Re: Variance Request  
Hills of Town Creek Section 5 (Dev. No. 2406)  
City of Montgomery

LOT 27 AND 28 REPLAT EXHIBIT  
 0.4718 ACRES (20,550 SQ. FT.)  
 ALL OF LOTS 27 AND 28  
 OUT OF THE HILLS OF TOWN CREEK  
 SECTION 5  
 RECORDED UNDER  
 CABINET Z, SHEET XXXX M.R. M.C.T.  
 IN THE  
 BENJAMIN RIGBY SURVEY, A-31  
 MONTGOMERY COUNTY, TEXAS

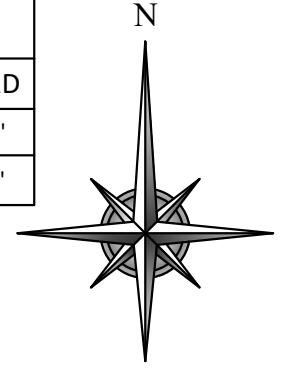
We find no issue with the variance request as submitted, and will require that the Developer submit plans to the access path, and playgrounds to ensure that the City's waterline remains free of obstructions.
